# PSL - PMC

## PMC Servo Rev E01

Engineering Change Order History		
ECO number	Date	Originator
1	E010166 to Rev C	RR
2	E010223 to Rev C1	RR
3	E010331 to Rev D	RR
4	E010332 to Rev E	RR
5

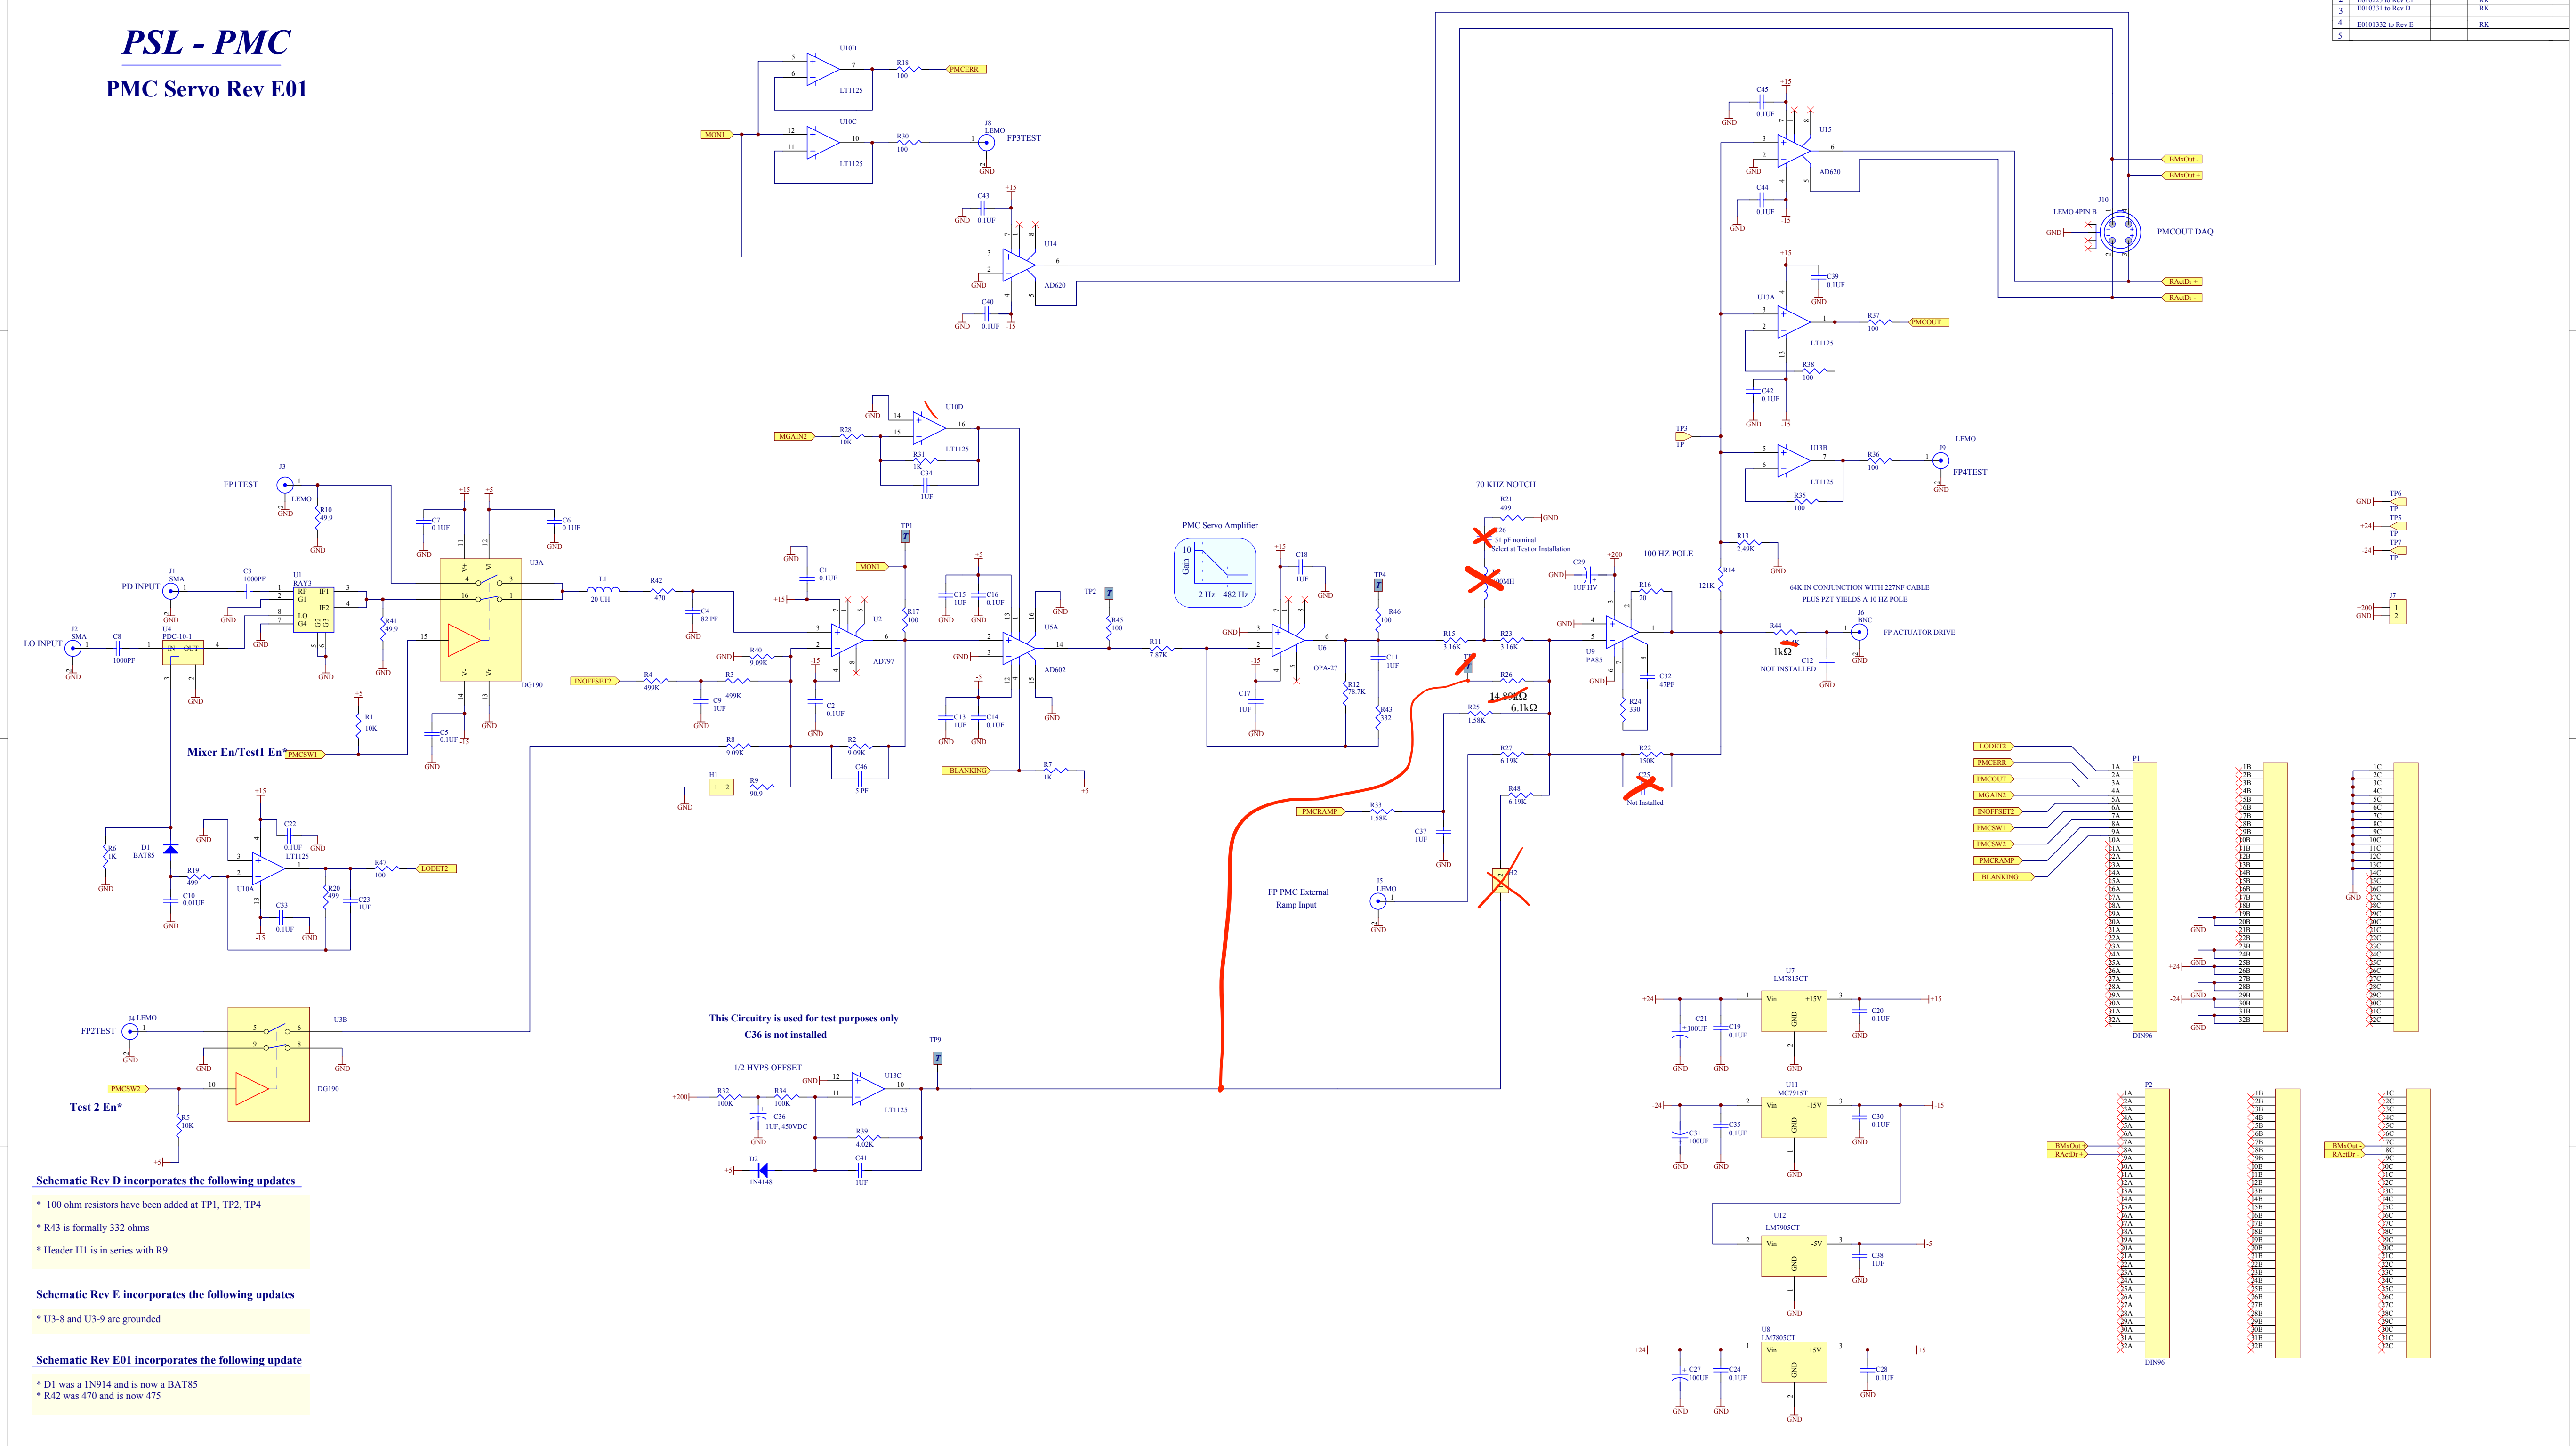
**Schematic Rev D incorporates the following updates**

- \* 100 ohm resistors have been added at TP1, TP2, TP4
- \* R43 is formally 332 ohms
- \* Header H1 is in series with R9.

**Schematic Rev E incorporates the following updates**

- \* U3-8 and U3-9 are grounded

**Schematic Rev E01 incorporates the following update**

- \* D1 was a 1N914 and is now a BAT85
- \* R42 was 470 and is now 475
